# Service Bulletin

**SUBJECT:** Service Update for Inventory and Customer Vehicles  
Turbo-to-Exhaust Manifold Joint May Relax  
Expires with Base Warranty

**MODELS:** 2013 Cadillac ATS  
2013 Chevrolet Malibu  
Equipped with 2.0L Engine (LTG)

Subject: 13013A – Service Update  
Turbo-to-Exhaust Manifold Joint May Relax  
Revised Service Procedure

3268362

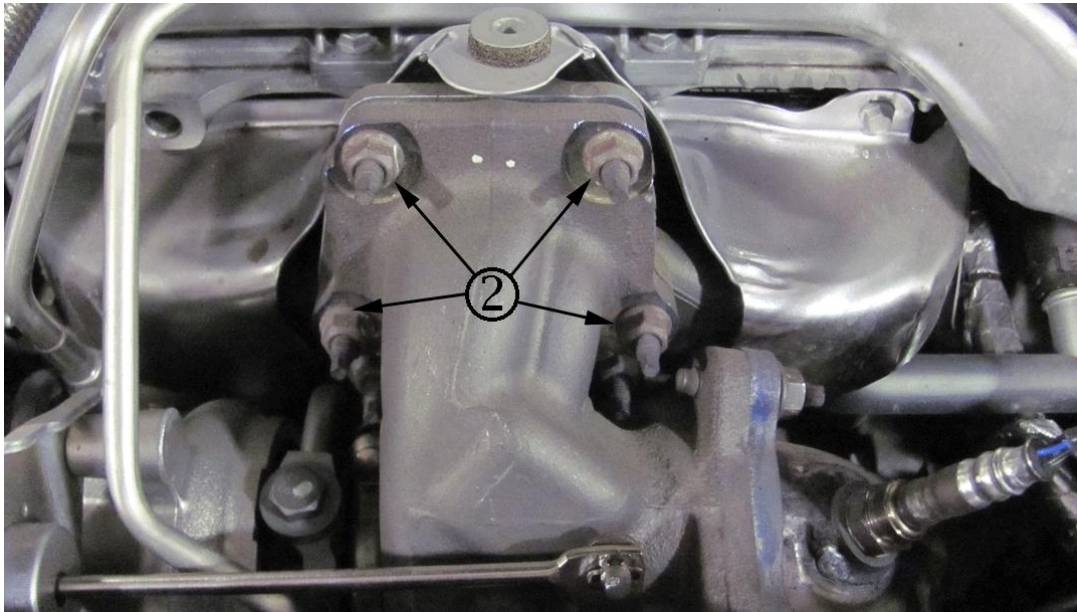
2. Locate the turbocharger exhaust heat shield (1).

4. Loosen the four turbocharger-to-exhaust manifold nuts (2).
5. Tighten the four turbocharger-to-exhaust manifold nuts (2) to **30 Nm (22 lb-ft) + 90 degrees**.
6. Re-install the turbocharger exhaust heat shield. Refer to *Exhaust Manifold Heat Shield Replacement (LTG)* in SI.
7. Tighten turbocharger exhaust manifold heat shield fasteners to **9 Nm (80 lb-in)**.
8. Close the hood of the vehicle.
